Access Compliance Report

Public Rights-of-Way

Intersection ID: 2725	Main Street: SKYLINE_DR	Cross Street: SKYLINE_DR	Location: NW
ADA ID: 3AD8E4ED30E3	Ramp Type: PerpDiag	Initial Pass/Fail: Fail	Overall Compliance: No
		Severity Score: 58.75

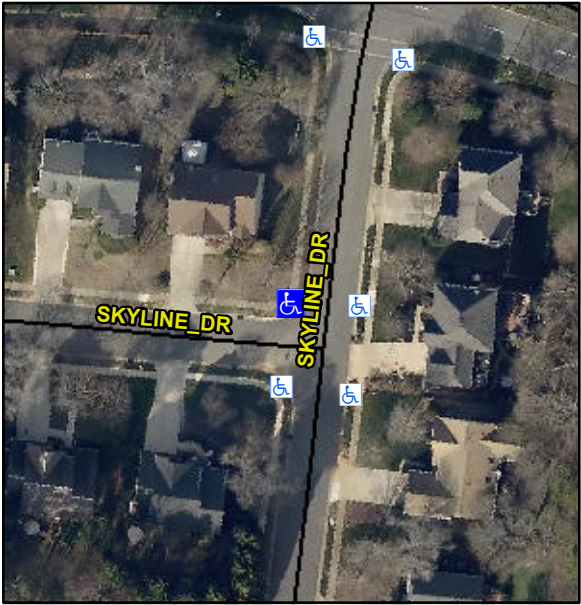
Codes/Mitigation Info/Possible Solution			Field Measurements/Component Compliance		
	Possible Solutions:		Compliance	Description	Data
	Remove & Replace Curb Ramp With Two New Directional Ramps or Equivalent.		No	Ramp Length (in)	50.0
			No	Ramp Width (in)	44.0
			N/A	Flare Type LT	N/A
			N/A	Flare Slope LT (%)	N/A
			N/A	Flare Traversable LT?	N/A
			N/A	Landing Length (in)	N/A
			N/A	Landing Width (in)	N/A
			N/A	Landing Slope (%)	N/A
			N/A	Landing X Slope (%)	N/A
<p>Surveyor Notes:</p> <p>N/A</p> <p>PROW/ADA:</p> <p>Not Found, R304.5.1, R304.2.2, R304.5.3</p>			N/A	Flare Type RT	N/A
			N/A	Flare Slope RT (%)	N/A
			N/A	Flare Traversable RT?	N/A
			N/A	DWS Provided?	N/A
			N/A	DWS Contrast?	N/A
			N/A	DWS Length (in)	N/A
			N/A	DWS Full Width?	N/A
			N/A	DWS Offset (in)	N/A
			N/A	Gutter Ponding?	N/A
			N/A	Gutter Lip Ht (in)	N/A
			No	Painted X Walk1?	No
				X Walk 1 Direction	To S
			N/A	X Walk 1 Width (in)	N/A

9.8	X Walk 1 Slope (%)	0.4
			6.8	X Walk 1 X Slope (%)	10.0
			N/A	Ramp inside XWalk1?	N/A
			9.5	Road Slope (%)	N/A
			3.7	Road X Slope (%)	N/A
			N/A	Any Obstructions?	N/A
				Obstruction Type	
Total Cost: \$ 3200.00			N/A	Storm Grate/Utility Hazard?	N/A
			N/A	Storm Grate/Utility Type	N/A
			Yes	Surface Condition? (G/P)	Good
